May 17, 2017

RE: Donald Lum Elementary School Liquefaction Settlement

Figure 1 - Existing Footing

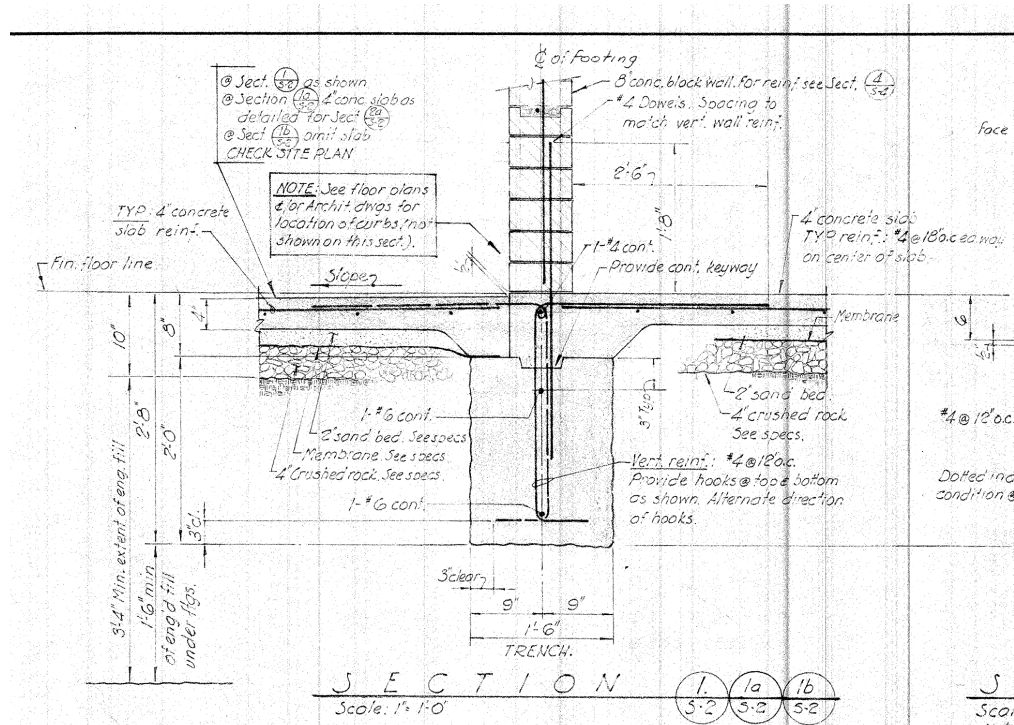
The foundations for the earliest buildings, built in 1959-1964, are shallow, relatively narrow footings with a relatively small amount of steel reinforcing. A typical footing section can be seen in Figure 1. In this example, the footing is 24 inches deep and 18 inches wide with one reinforcing bar in the top and another in the bottom of the footing. The later building, built in 1974, is slightly more robust with more footing reinforcement. These footings were designed to support the building weight directly on the soil below. They are not designed for, or adequate to transfer building weight over significant distances to bridge across soil that has lost its strength due to liquefaction. This was, and is, standard practice for building sites with good or average soil conditions. Even modern well designed buildings generally do not have adequate

foundations to withstand the 7" of expected differential settlement expected at Donald Lum Elementary School unless they were specifically designed for it.

We evaluated the existing footings in a couple of typical locations, using ASCE 41-13 Seismic Evaluation and Retrofit of Existing Structures, to span over a length of 25 feet which is similar to other designs of new buildings on liquefiable soil and in conjunction with the Geotechnical Engineer. Based on our analysis, the footings do not have the strength to span this distance and will likely experience displacement matching the liquefaction settlement of the soil below, leading to partial or global collapse of the structure above.

Figure 2 - Typical New Footing

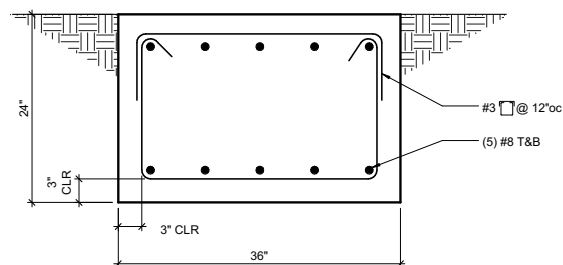
While we believe a stiffened grid foundation to resist the large settlements expected at Donald Lum Elementary School is not the appropriate system for this site, we did calculate what a potential required size might be. Figure 2 indicates a preliminary foundation size for a portion of the building based on a 25-foot unsupported footing length. While this solution is feasible from a structural perspective, it would be difficult or impossible to construct under an existing structure. If pursued, this foundation system would be required to be installed under all bearing walls and in a regularly spaced grid across the building.
